RENESAS TECHNICAL UPDATE

Product Category	MPU/MCU	Document No.	TN-RX*-A0281A/E	Rev.	1.00
Title	Errata Regarding Setting of the RCR4.RCKSEL Bit for the RX671 Group MCU		Information Category	Technical Notification	
Applicable Product	RX671 Group	Lot No.	Reference Document	RX671 Group User's Manual: Hardware Rev.1.10 (R01UH0899EJ0110)	
		All

Figure 31.3 Clock and Count Mode Setting Procedure

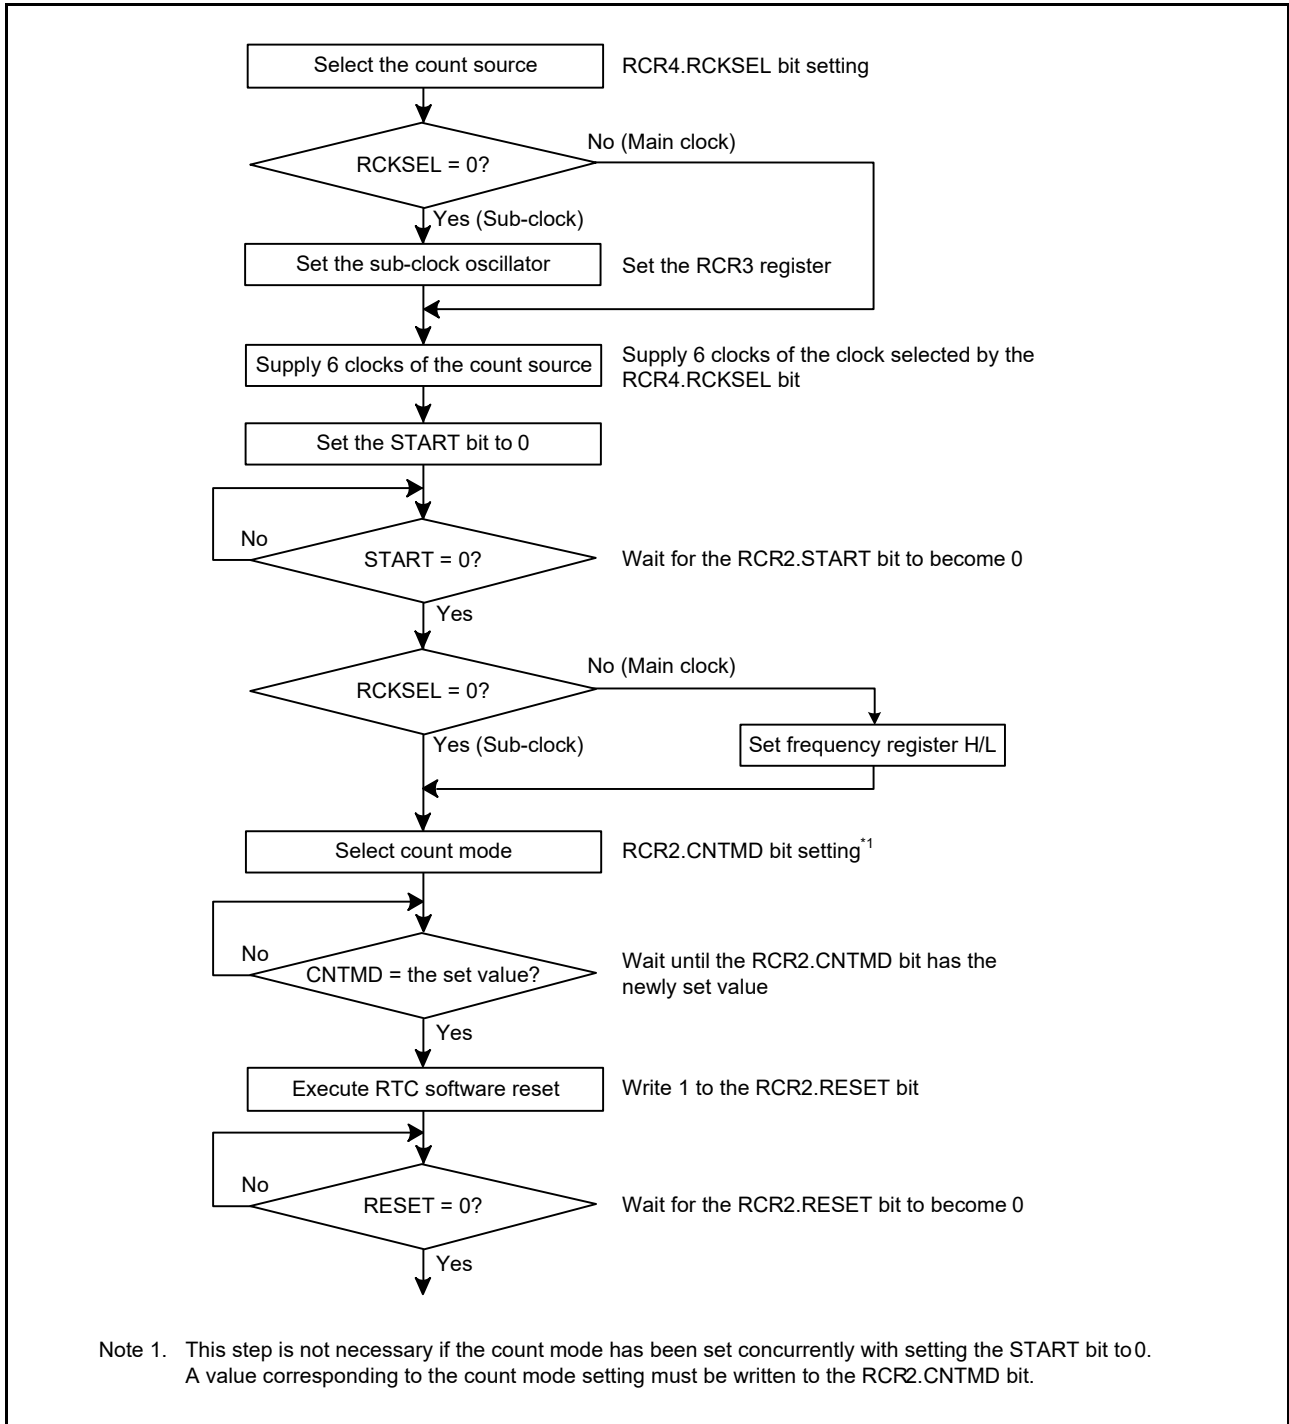
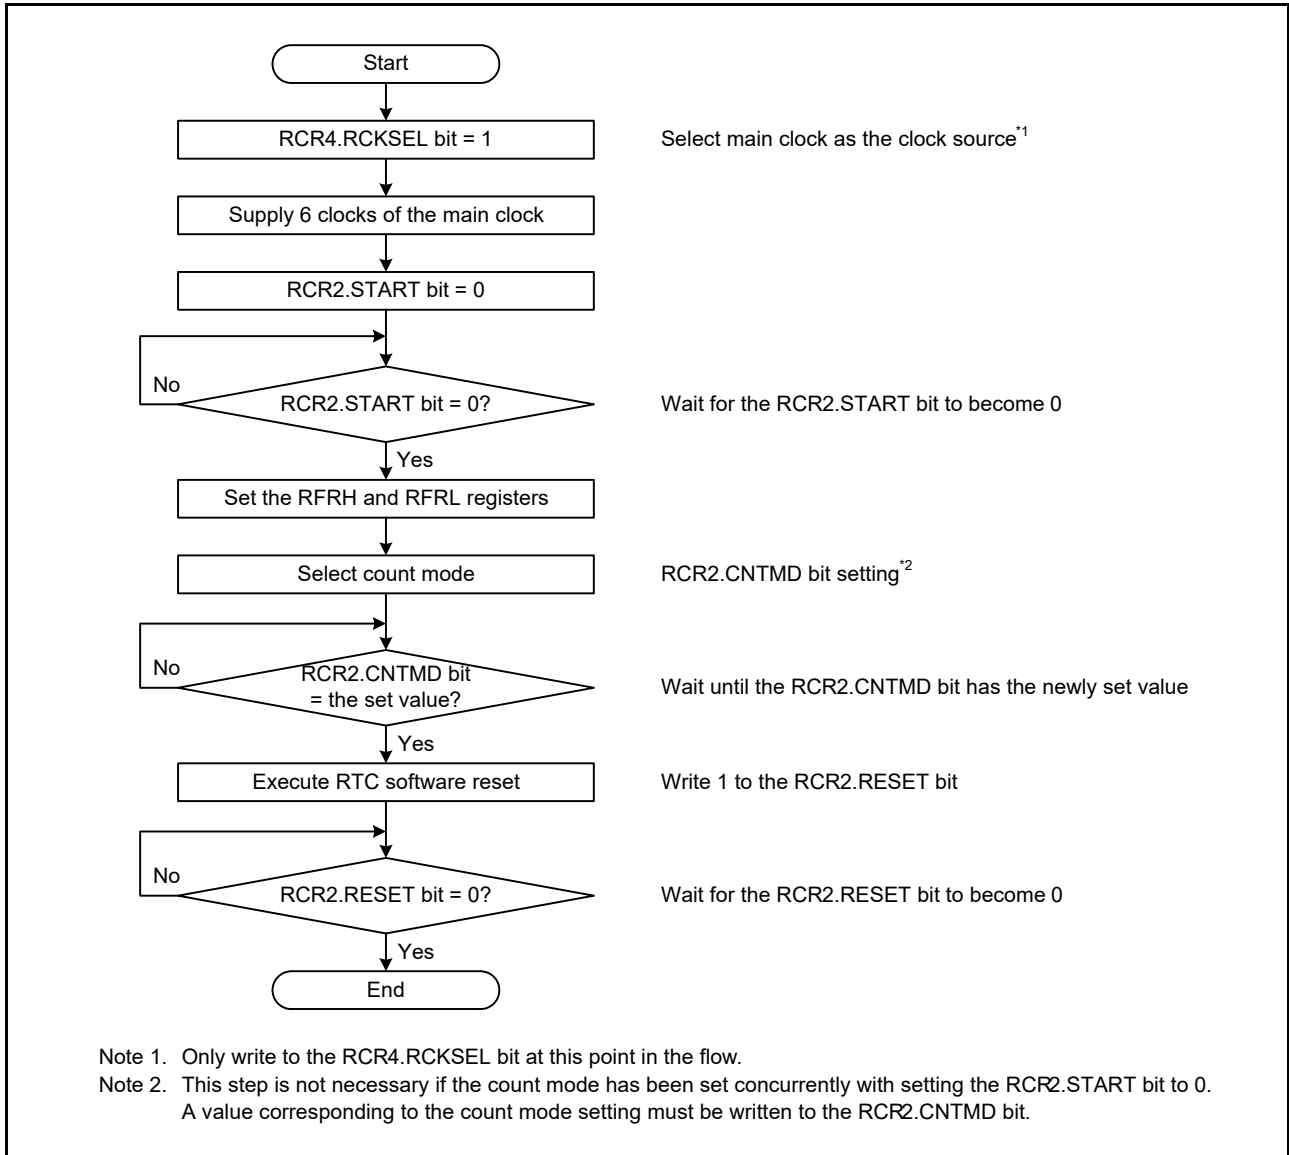
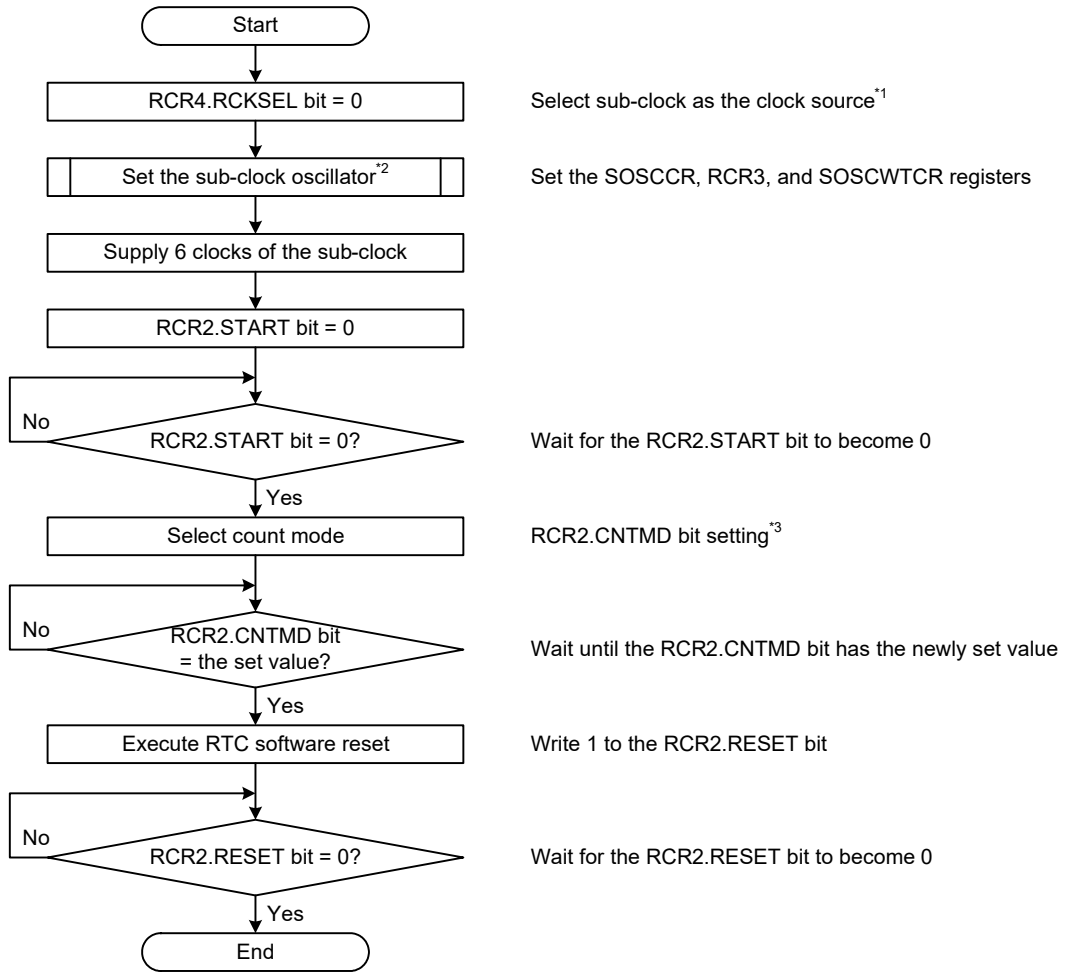
Figure 31.3, Clock and Count Mode Setting Procedure, in section 31.3.2, Clock and Count Mode Setting Procedure, is separated into two flowcharts as follows to suit the clock that is in use.

- Note 1. Only write to the RCR4.RCKSEL bit at this point in the flow.
- Note 2. For the procedure for setting up a sub-clock oscillator, refer to section 9, Clock Generation Circuit.
- Note 3. This step is not necessary if the count mode has been set concurrently with setting the RCR2.START bit to 0. A value corresponding to the count mode setting must be written to the RCR2.CNTMD bit.

Figure 31.14 Initialization Procedure

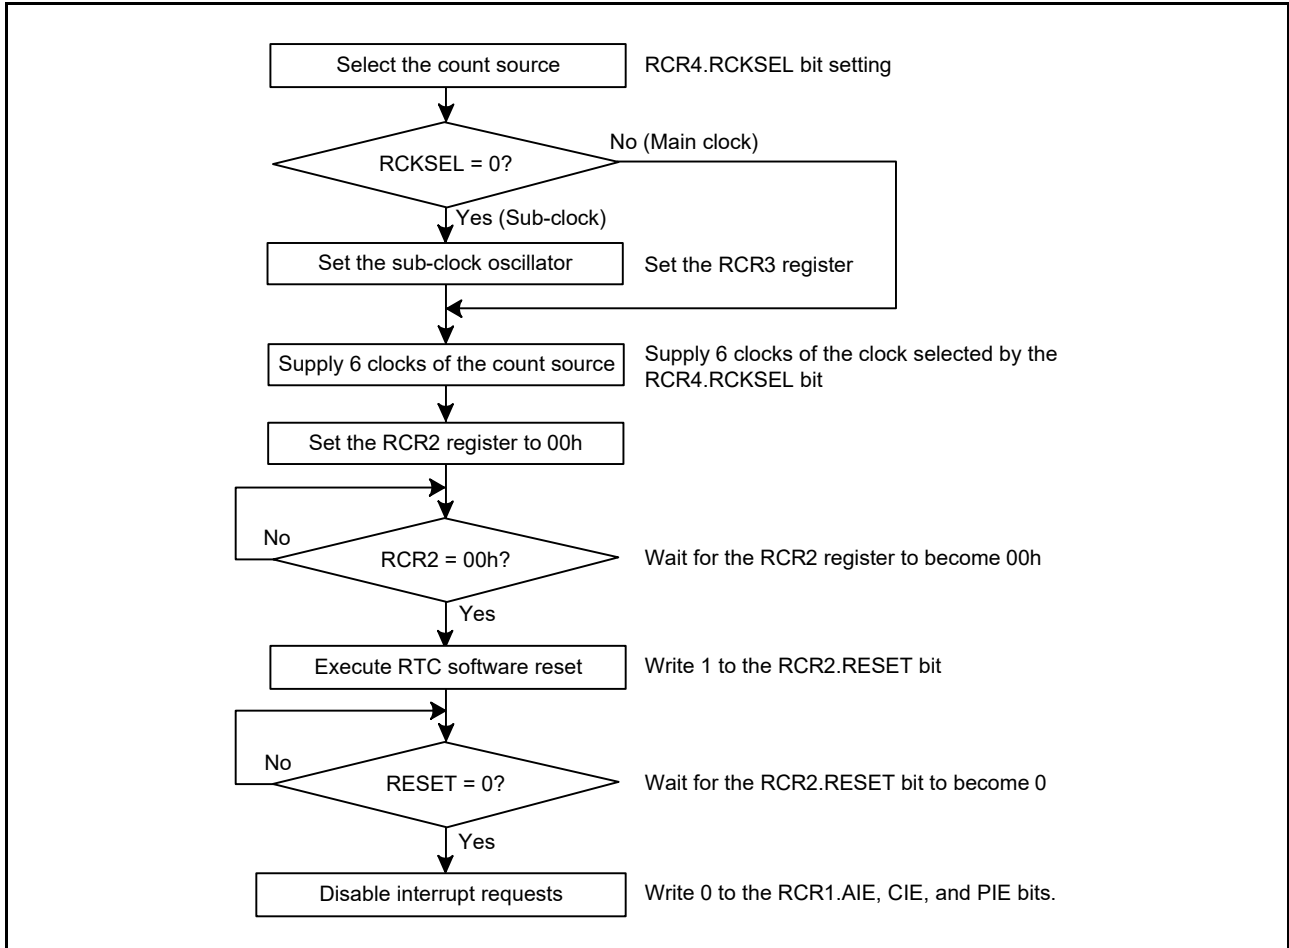
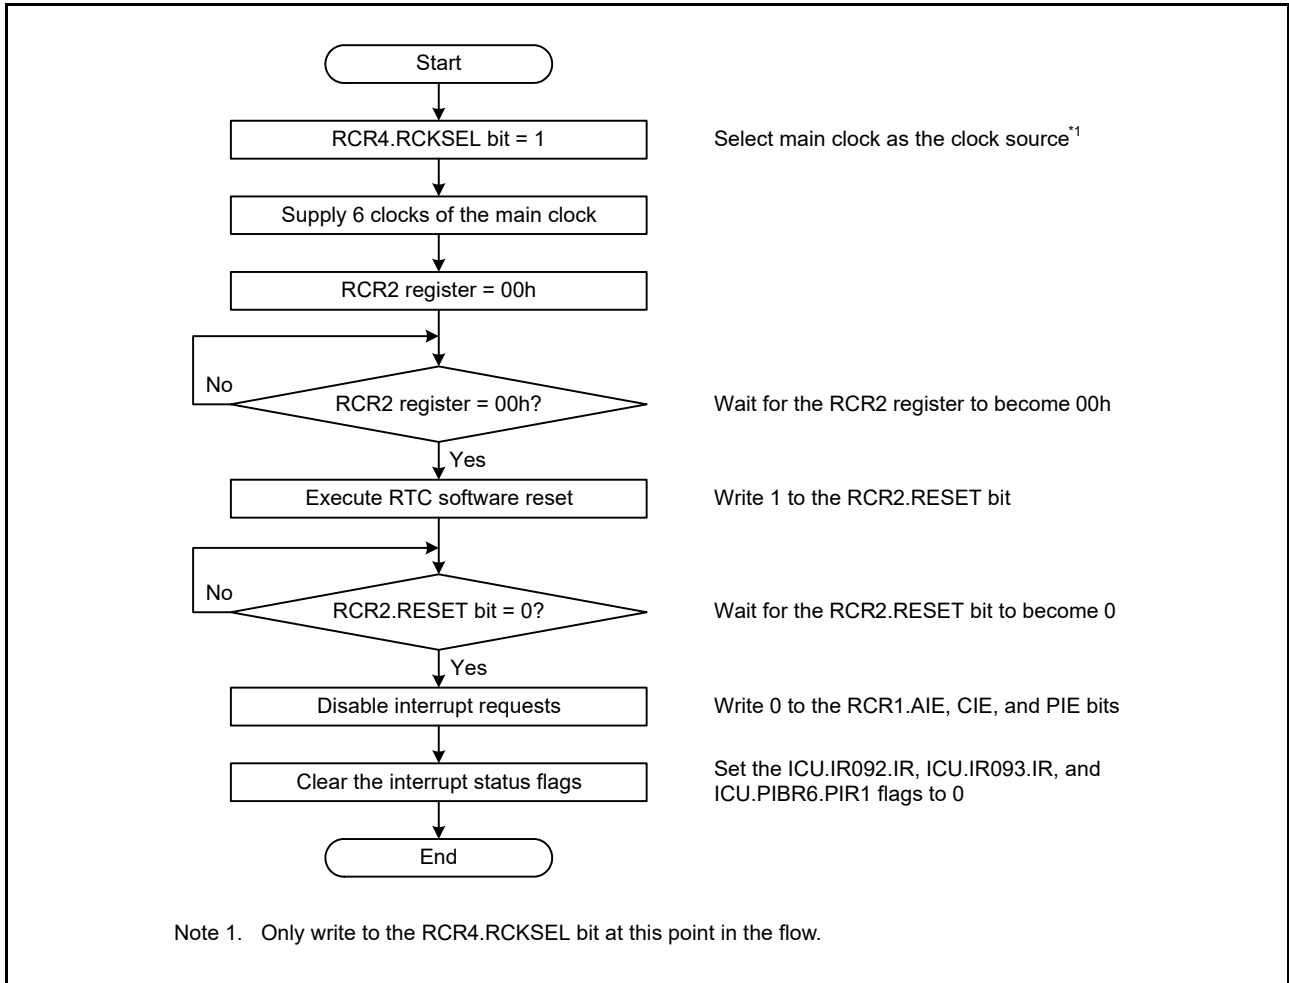
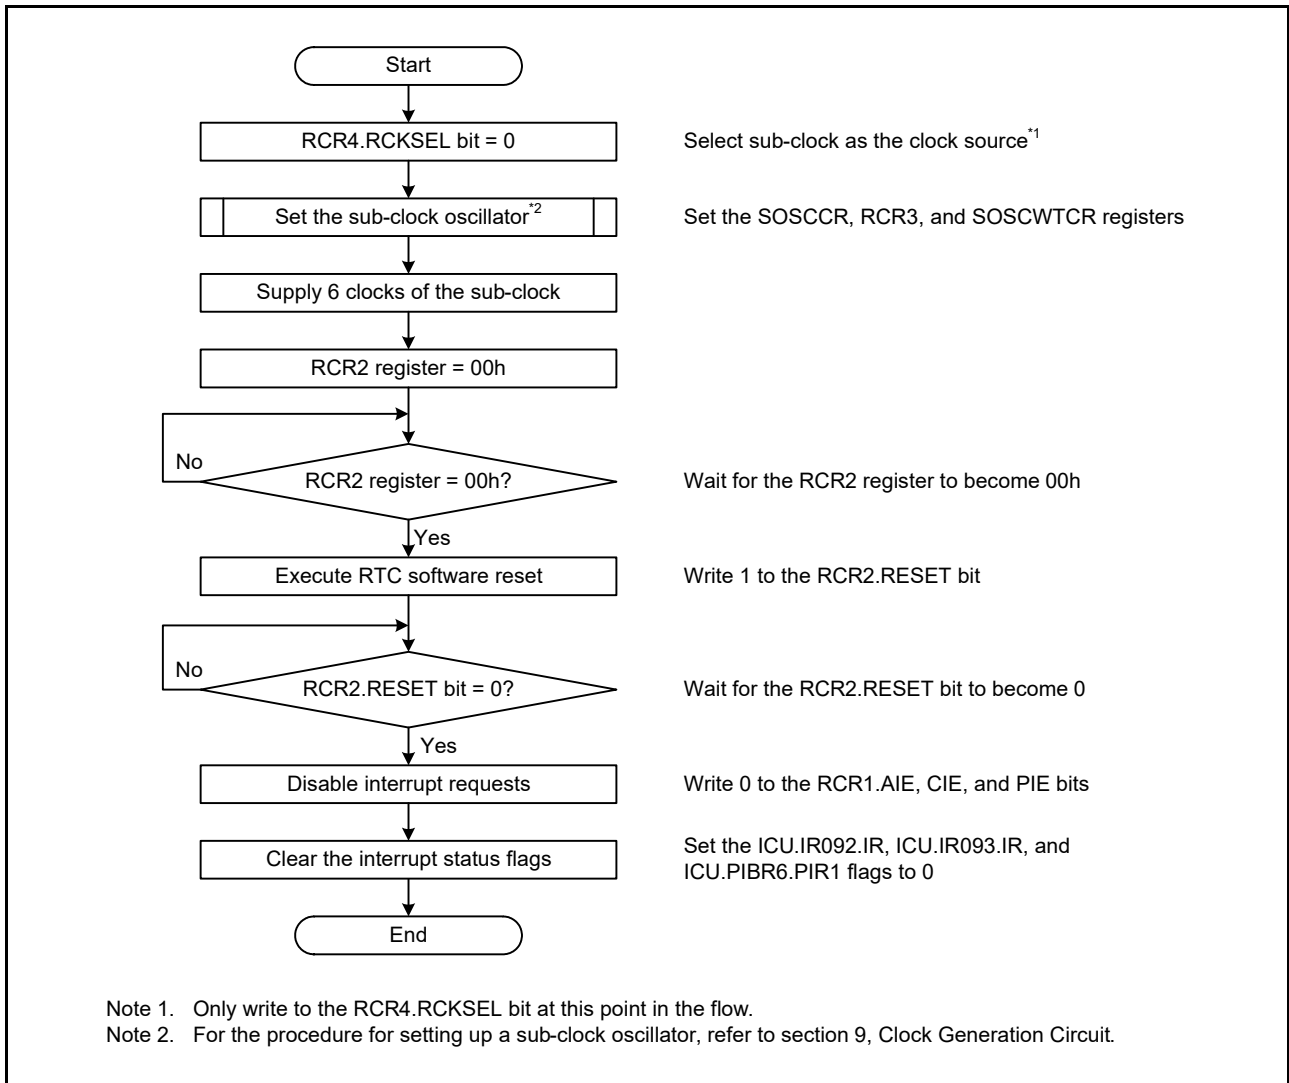
Figure 31.14, Initialization Procedure, in section 31.6.8, Initialization Procedure When the Realtime Clock is Not to be Used, is separated into two flowcharts as follows to suit the clock that is in use. A step of clearing the interrupt status flags is also added to both flowcharts.
